RE: Revised Application Deficiency Report #4 - Certificate of Public Convenience and Necessity for the Riverside Transmission Reliability Project – Application No. A.15-04-013

DEFICIENCY REPORT #4 (REVISED) FOR THE RIVERSIDE TRANSMISSION RELIABILITY PROJECT APPLICATION (A. 15-04-013)

Table 1: SCE Riverside Transmission Reliability Project Application 15-04-013 Deficiency Report #4 (Revised 09/22/2016)

**MAPBOOK SET ILLUSTRATING THE GEOGRAPHIC
EXTENT OF PREVIOUS CULTURAL RESOURCE
SURVEYS CONDUCTED BETWEEN 2006 AND 2011
SOUTHEAST OF THE SANTA ANA RIVER**

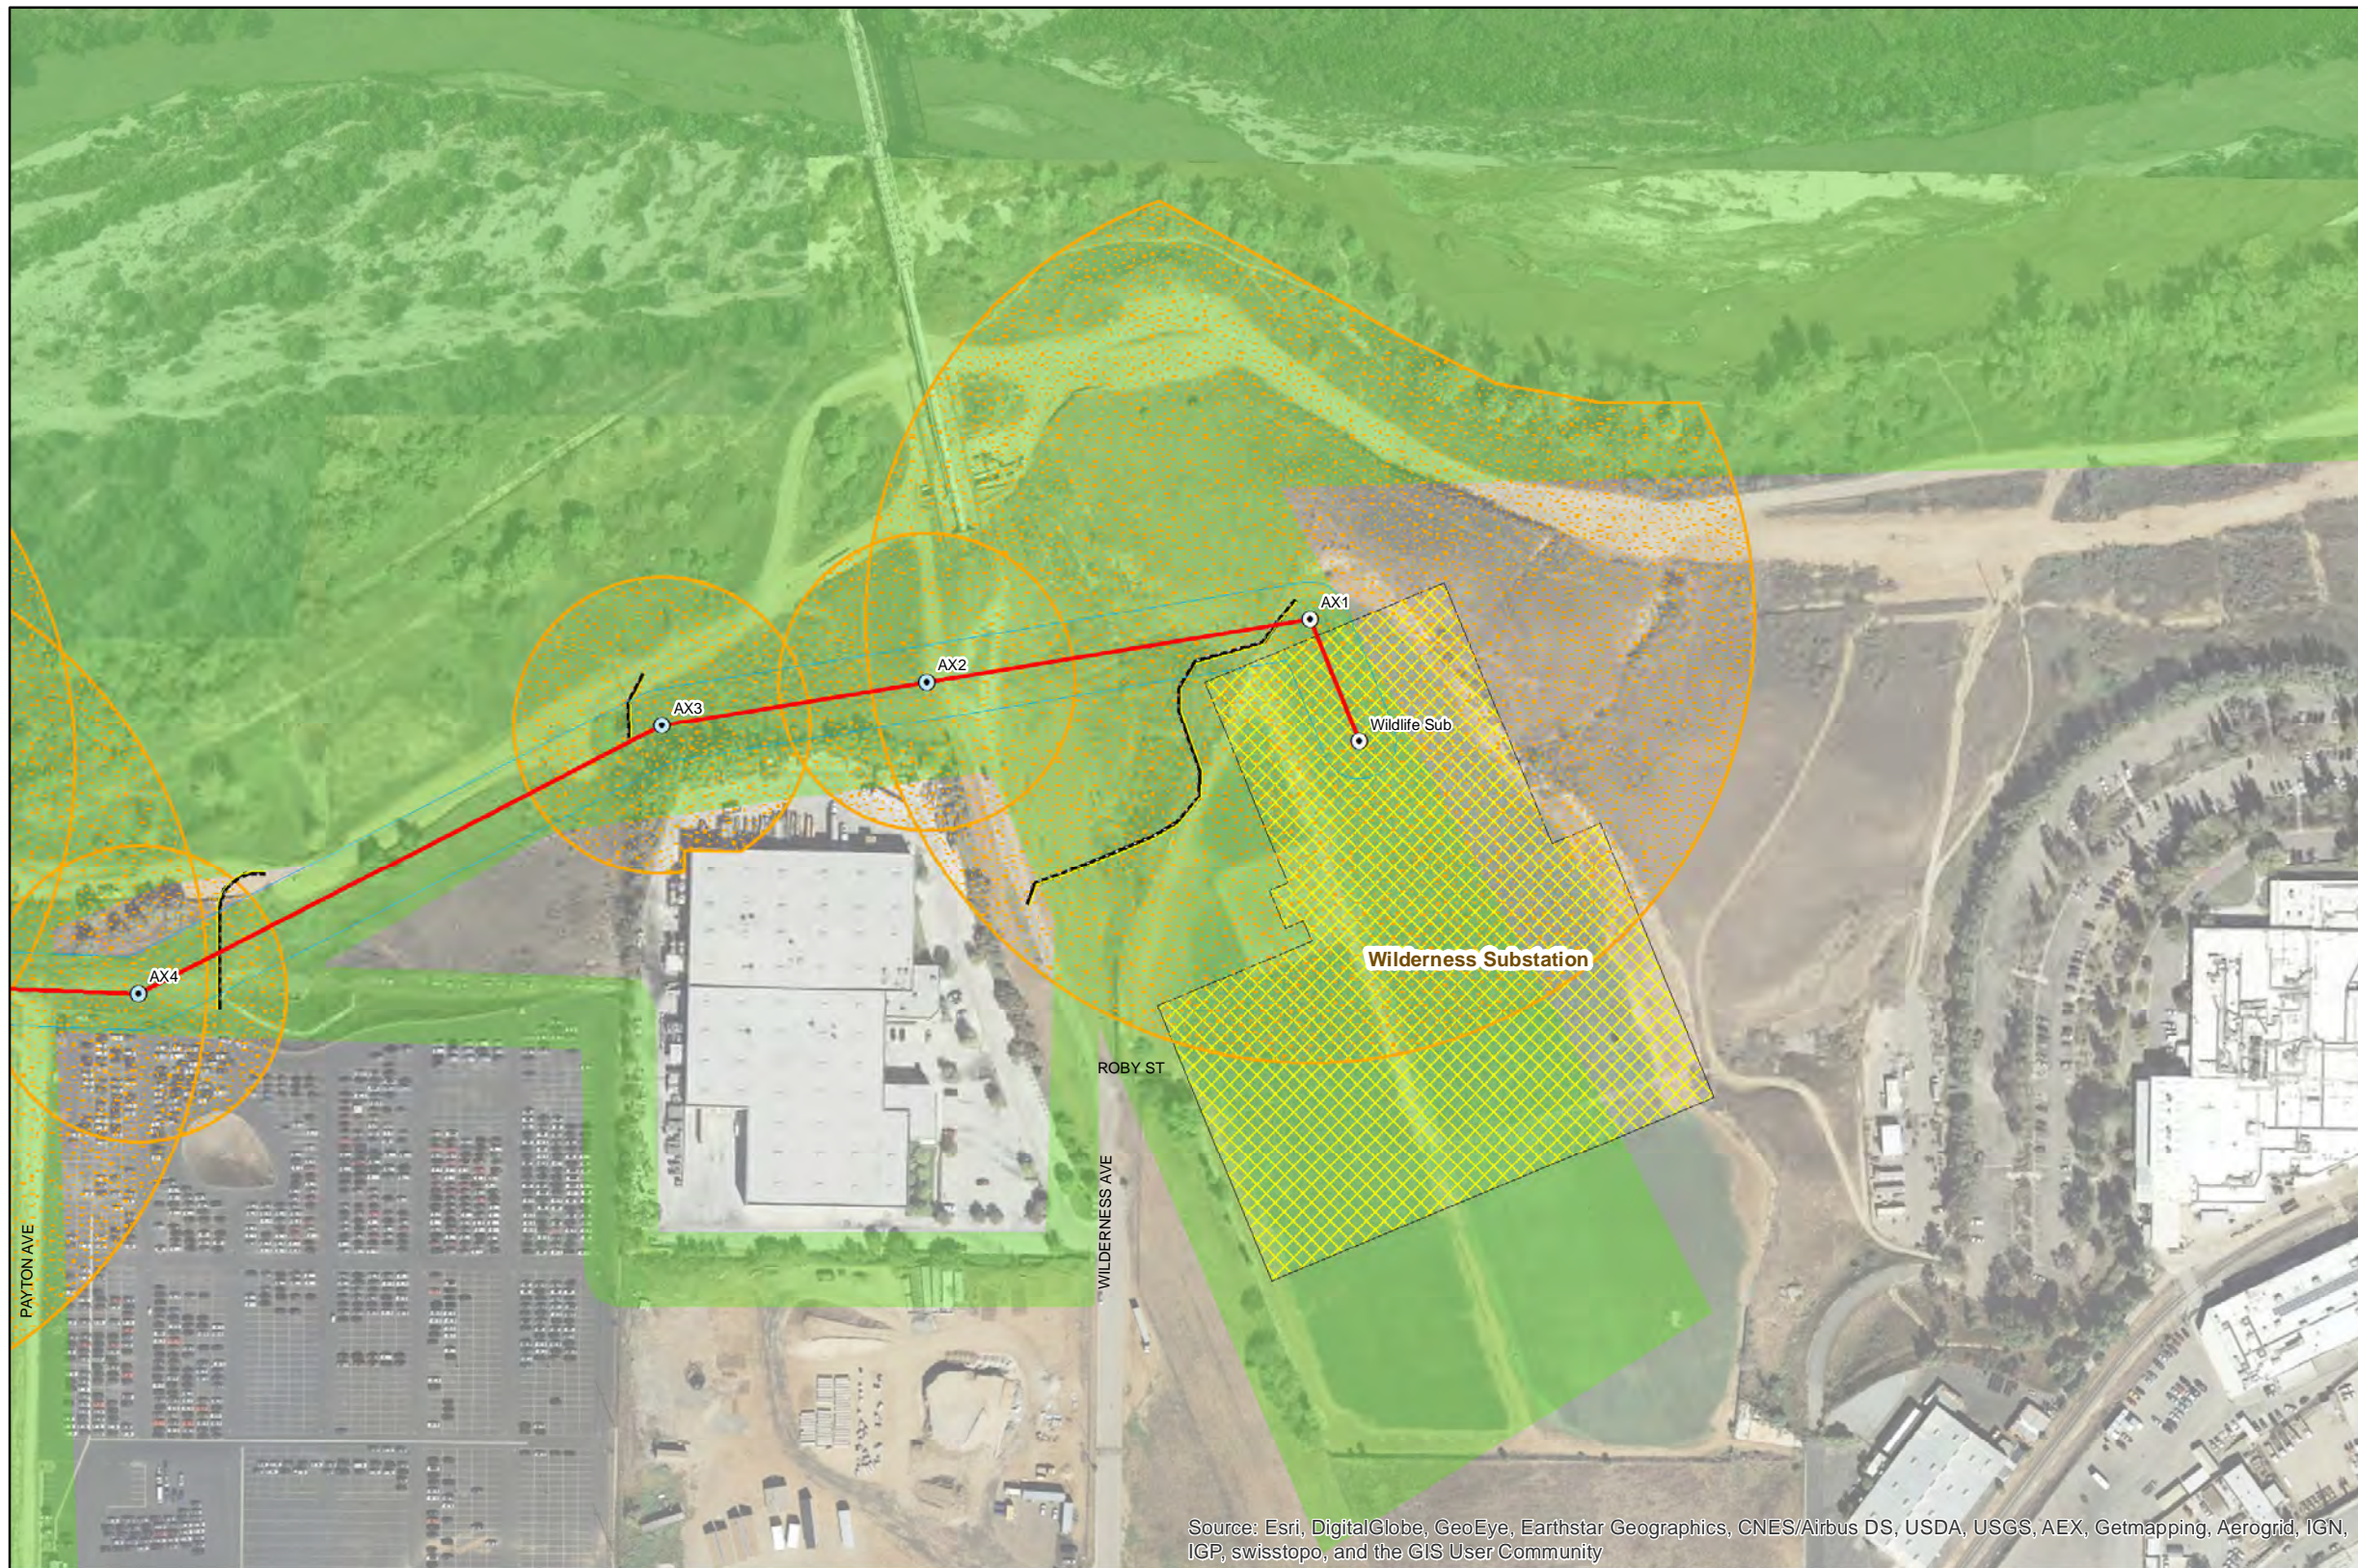
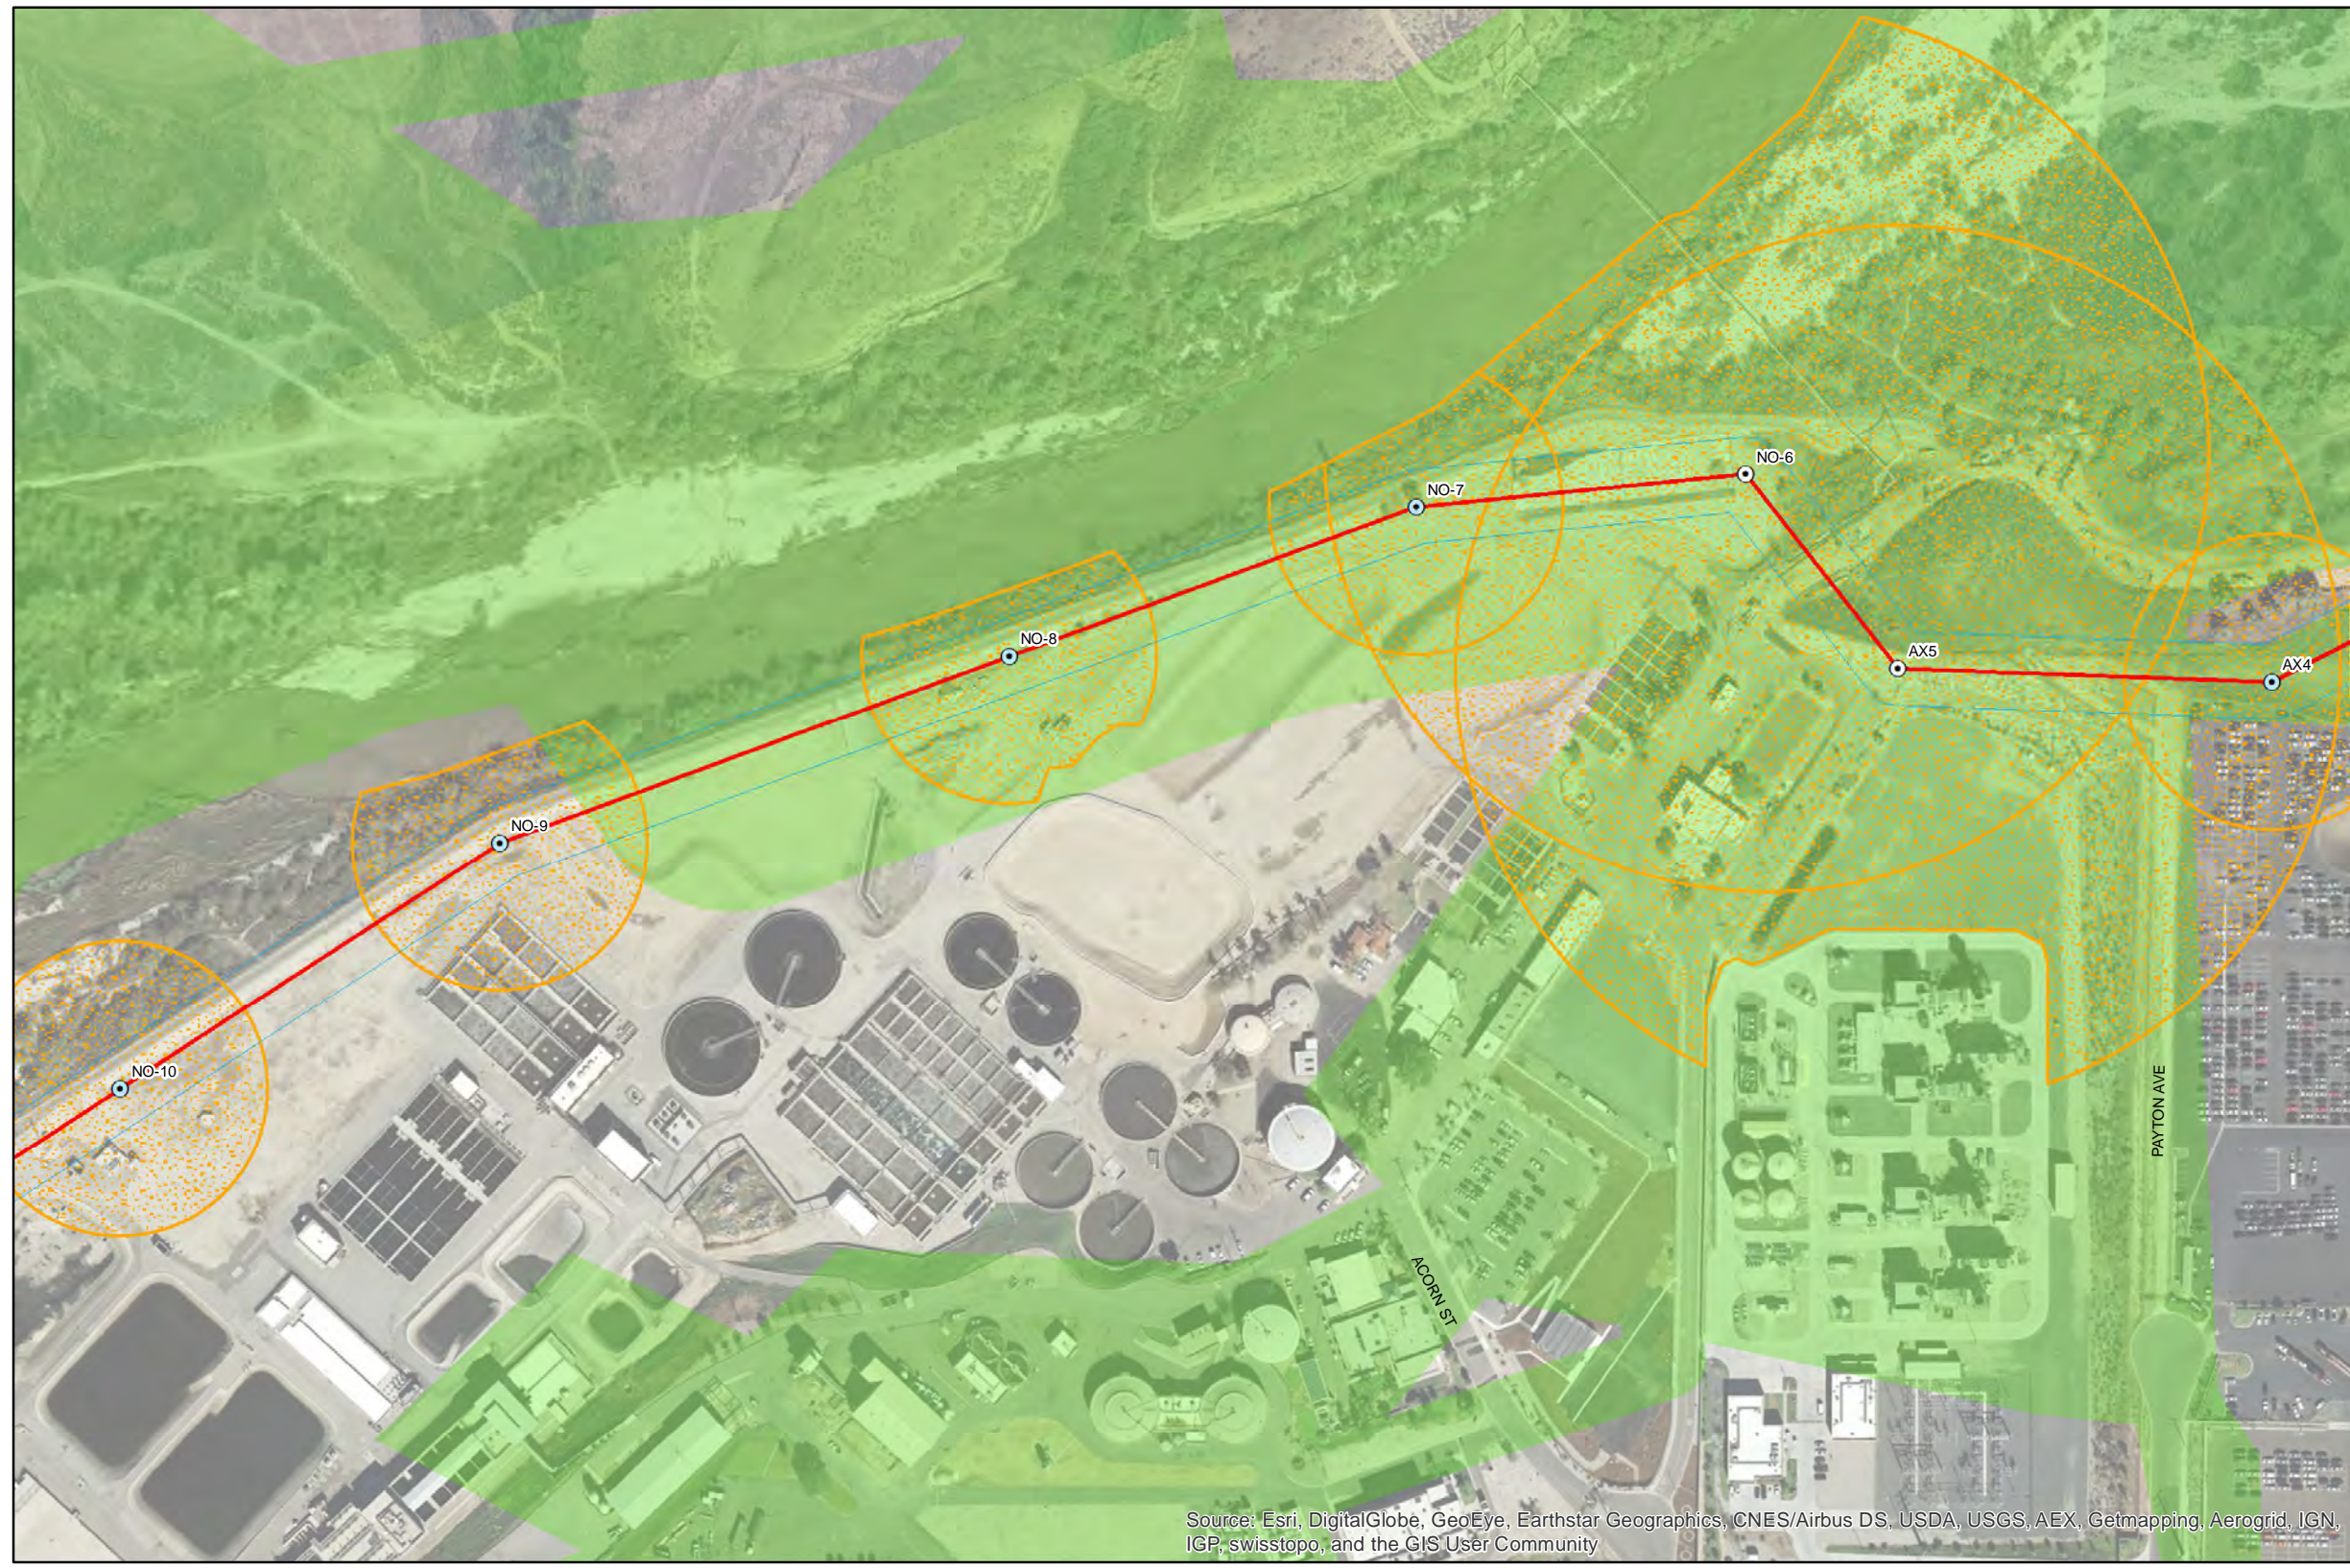
6	Yes	<p>Provide cultural resource survey reports and data for all unsurveyed portions of project disturbance areas as refined in response to Items 1 through 3</p>

Number	Information Requested Previously?	Deficiency
		<p>above (see also Attachment B) and the revised alignment northwest of the Santa Ana River.</p> <p>The cultural resource survey reports need to contain the results of a record search performed through the California Historical Resources Information System (CHRIS) – Eastern Information Center as well as the results of pedestrian surveys for all unsurveyed work areas along the overhead alignment including those areas shown on Attachment B, the agricultural area north of Limonite Avenue, and the underground alignment within the Goose Creek Golf Club. Please also provide the results of a cultural resources records search performed through the CHRIS for the proposed underground alignment within 68th Street and Pats Ranch Road. Provide all supporting details in the cultural resources survey report (i.e., site records and maps).</p>
7	Yes	<p>Clarify how SCE expects to obtain a permit for new poles located in the Hidden Valley Land and Water Conservation Fund (LWCF) area. How will NEPA be handled for new poles in this area? Where and how will SCE replace the impacted LWCF area?</p> <p>The Land Use section in the 2013 RTRP Final EIR lacks analysis of the land use impacts resulting from conversion of LWCF areas. Mitigation Measure REC-02 in the recreation section does not define where or how SCE would replace the LWCF area or obtain the necessary permits from the National Park Service. Further information is needed to verify the feasibility of the proposed “land conversion” for the proposed transmission line structures within the LWCF area.</p>
